Subject: Comments on Section V.P. (Water Resources) of Laetitia RRDEIR

Cleath-Harris Geologists (CHG) has reviewed the water resources portion of the July 2013 Revised Recirculated Draft Environmental Impact Report (RRDEIR) for Laetitia prepared by SWCA Environmental Consultants, including the Geosyntec Consultants reports in Appendix H.

June 7, 2012 Comments on Laetitia RDEIR

Subject: Comments on Section V, Chapter B (Water Resources) of Laetitia RDEIR

Figure 1
Well 10 Hydrograph - Phase 3
Laetitia Agricultural Cluster

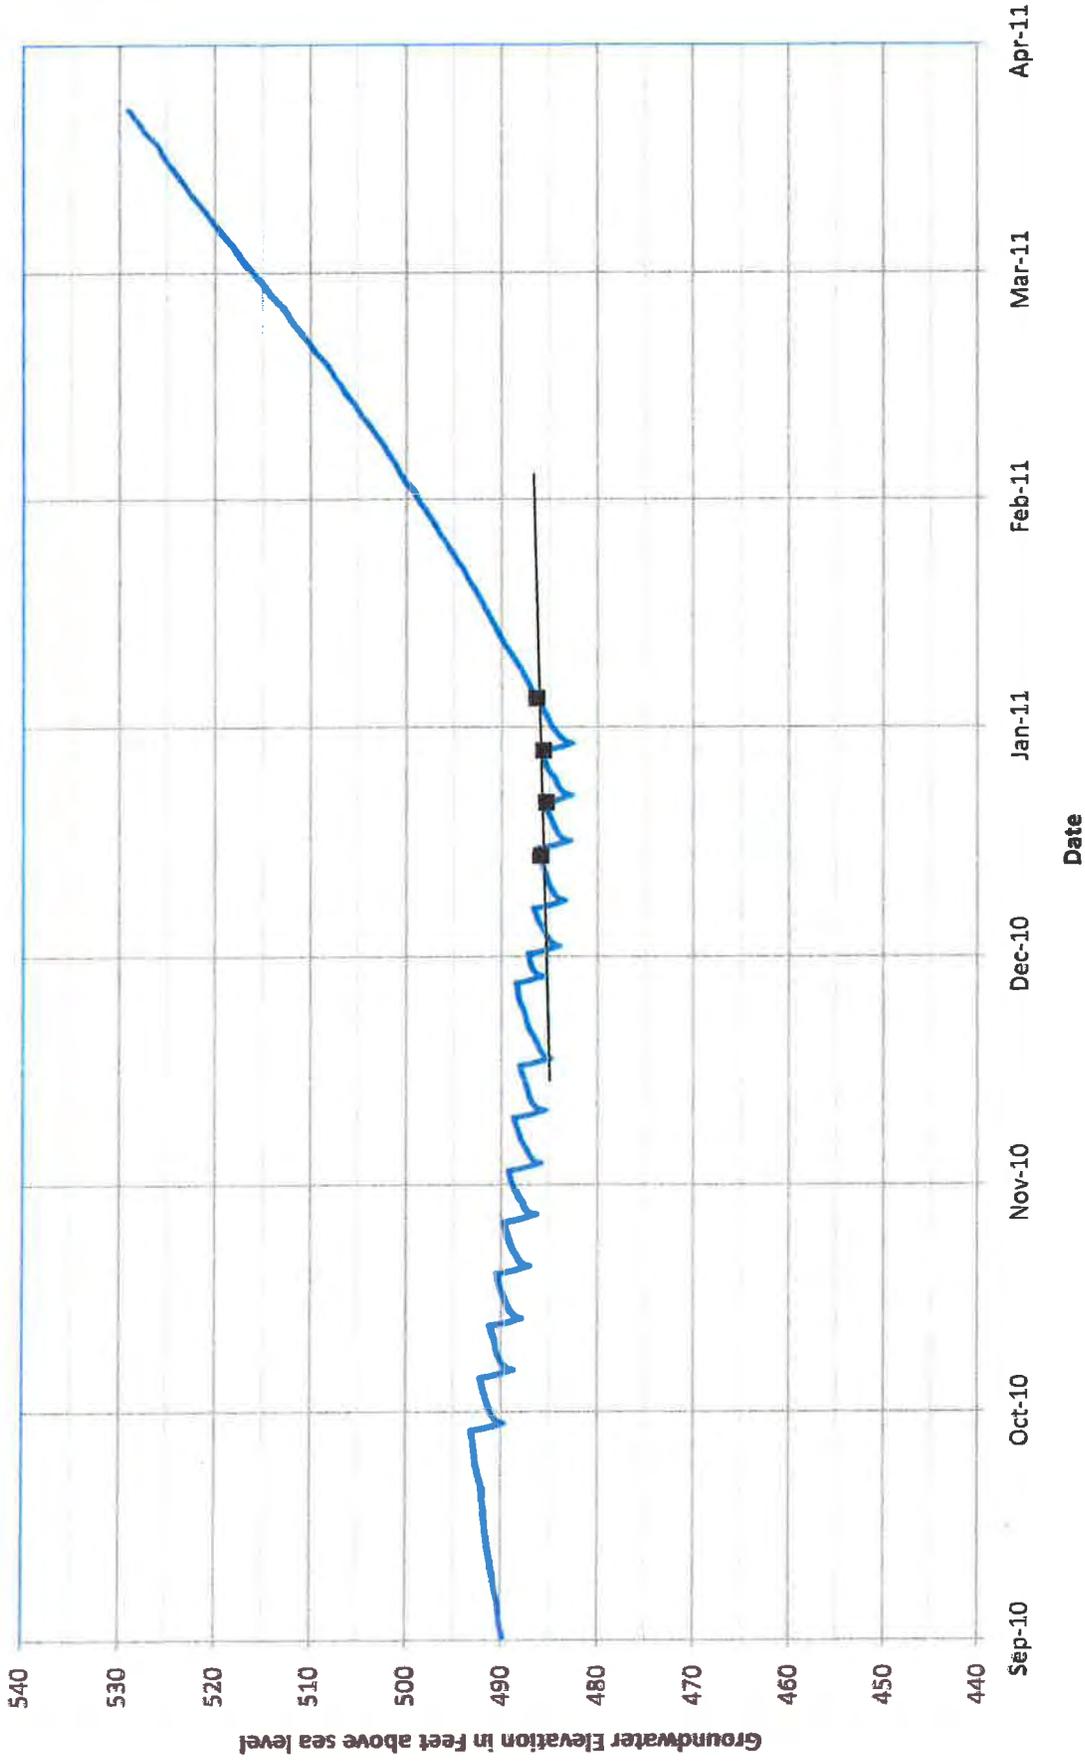
According to the report, Phase 3 testing established that water levels continued to drop at three of the four project wells, which is the primary reason given for discounting the sustainable yield values estimated by CHG. Geosyntec used trend lines to conclude that water levels in Well 10, 14, and 15 did not stabilize during the Phase 3 testing. These trend lines were incorrectly

projected over the entire Phase 3 data set (from the onset of pumping), rather than data from the end of Phase 3, when stability was evident.

Stability implies zero net water level drawdown over time. In order for water levels to stabilize at a pumping well, a cone of depression (drawdown cone) needs to develop and expand sufficiently to capture local recharge, which takes time. It is not appropriate to include the static water level and early drawdown data at a well when evaluating trends for water level stability.

The attached Figures 1 through 3 show Phase 3 hydrographs for the three wells in question. Water levels at all three wells stabilized during the last month of testing, as evident by the projected trend lines. Well 10 is stable (no net decline) over the last three cycles of pumping. Wells 14 and 15 are stable over the last five cycles of pumping.

Figure 4
Well 10 Hydrograph
Laetitia Agricultural Cluster

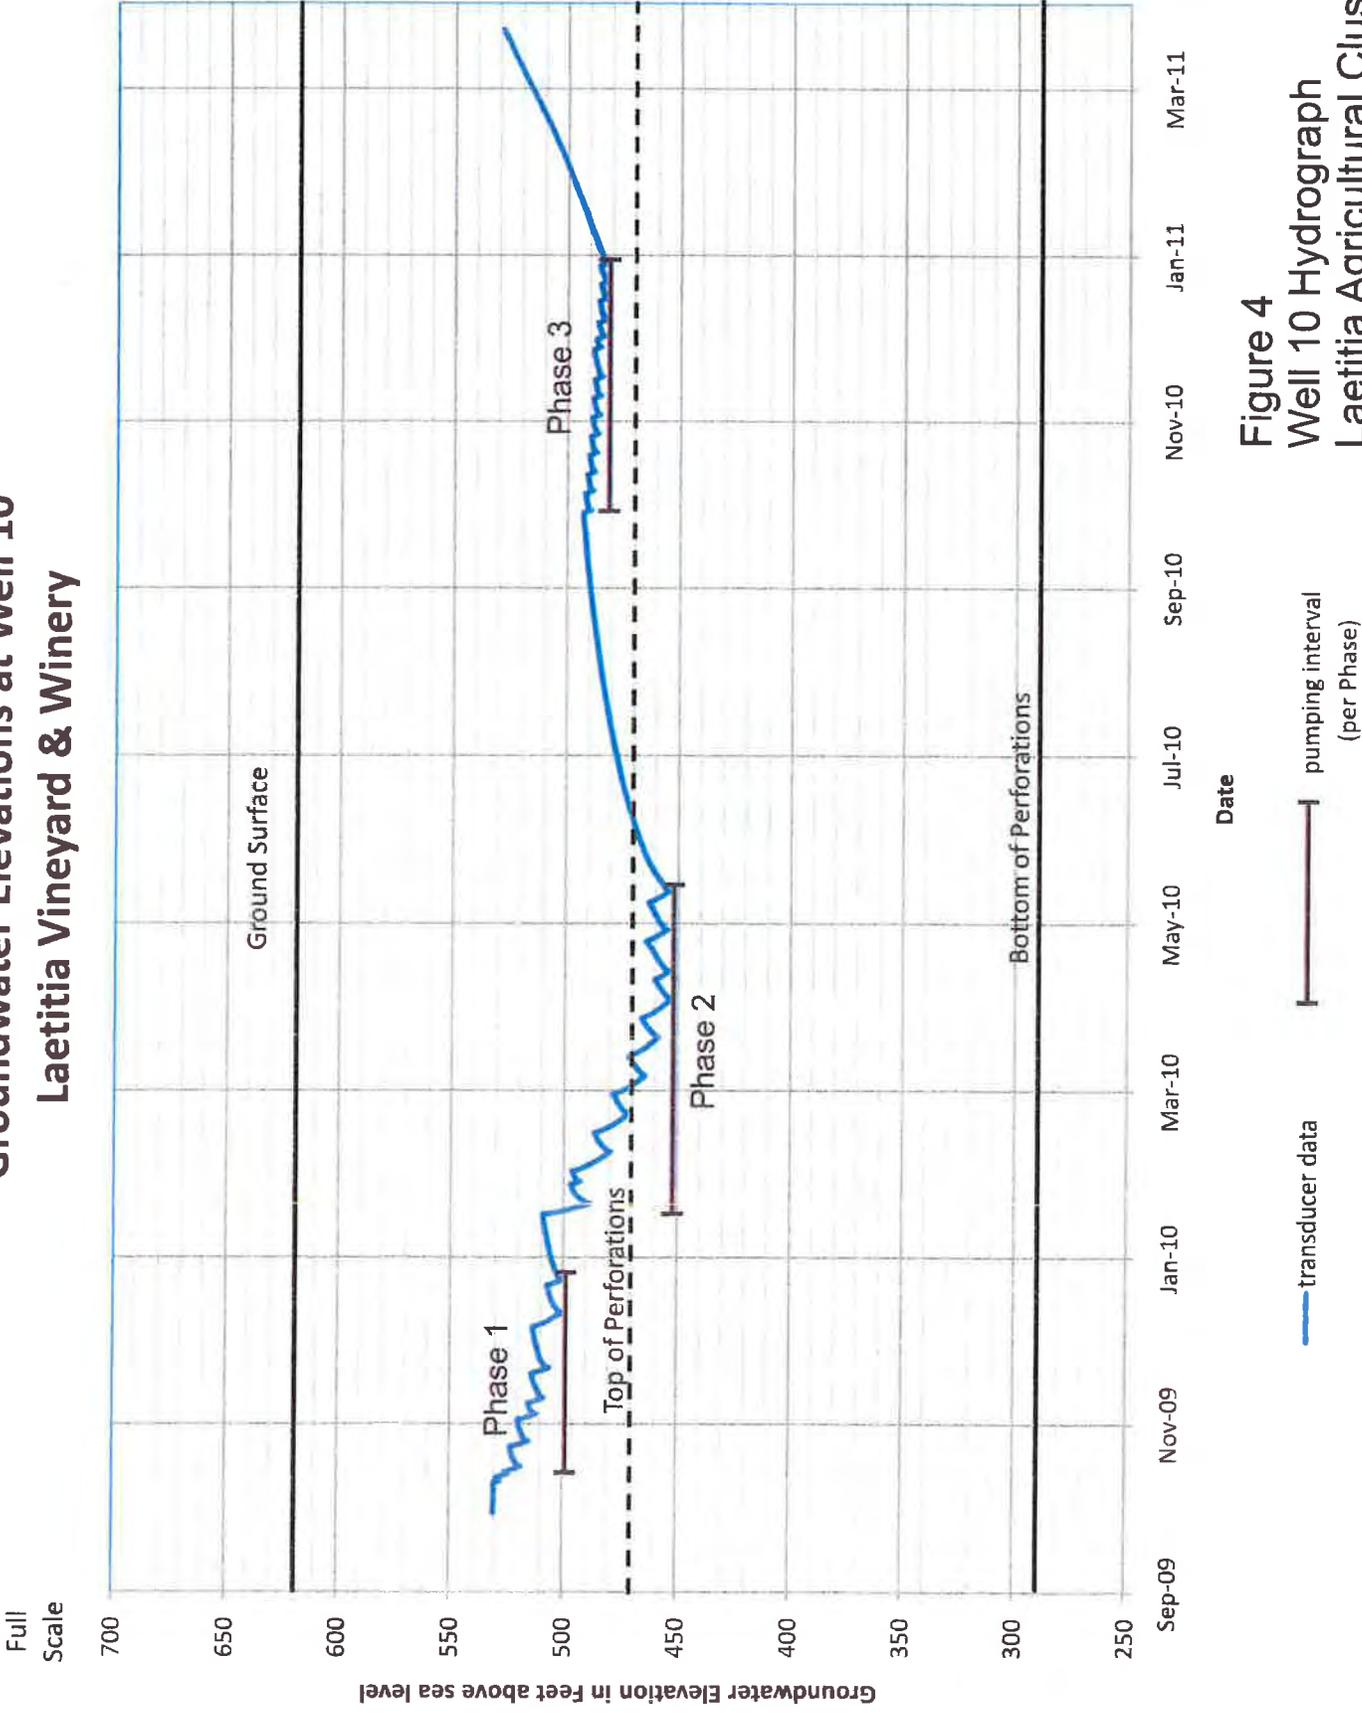
Continuing general decline of water levels in Wells 10, 14, and 15 during the three phases of pumping indicates that stable equilibrium groundwater conditions were not attained, and continued decline in water levels at three of the four wells during the Phase 3 pumping indicates that the 87 afy sustainable yield estimated by Cleath-Harris Geologists (2010) will not result in full recovery to "the Phase 1 operational static water levels", but will cause additional depletion of groundwater storage. (page V-66) V.P.-38

Water levels did not continue to decline during the three phases of pumping (see attached Figures 4 through 6). Water level drawdown at Wells 10, 14 and 15 during Phase 3 was less than during Phase 2 (i.e. water levels were higher), as anticipated, and also equilibrated in all wells prior to the end of testing (CHG 2011; see comment #1).

Figure 7
Updated Geosyntec Figure 18
Laetitia Agricultural Cluster

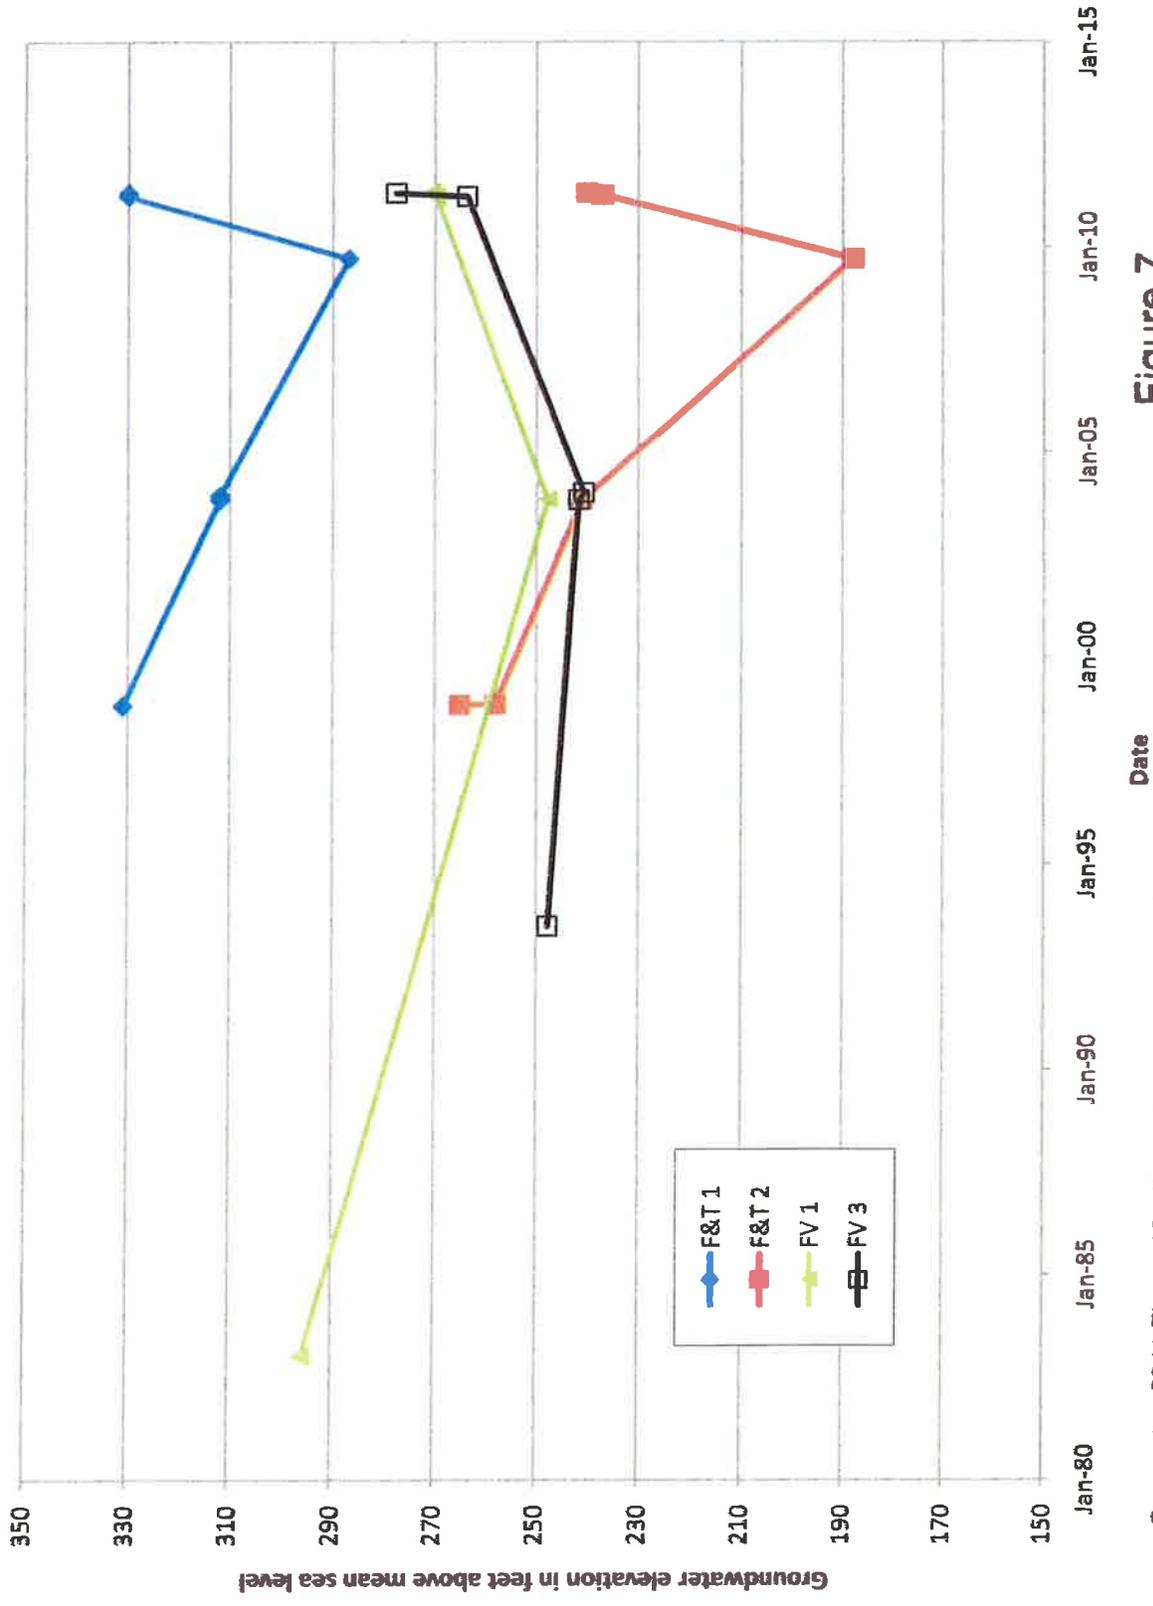
CHG provided supplemental water information, but that information showed rising trends (not downward trends) in the agricultural well water levels during the testing period. CHG provided a hydrograph of these four wells which is part of the attached June 7, 2012 comments to the RDEIR (Figure 7, attached). Detailed water level hydrographs for Well 5 and Well 9 are also shown in Figure 16 of Geosyntec's 2011 report and also show rising water levels during testing.

Although there are only a few data points for Wells F&T-1, F&T-2, FVW-1, and FWV-3, over periods of several years, the data show a general decline in groundwater elevation at these wells over 30 years. (page V-67) V.P.-41

The RDEIR updates agricultural well production for 2011 but for some reason does not update Figure 18 (water levels), which only includes measurements through September 2009 (drought). CHG has attached an updated figure to reflect spring 2011 measurements (within the time frame of RDEIR analysis). As shown in the updated figure, water levels have recovered following the recent drought (attached Figure 7).
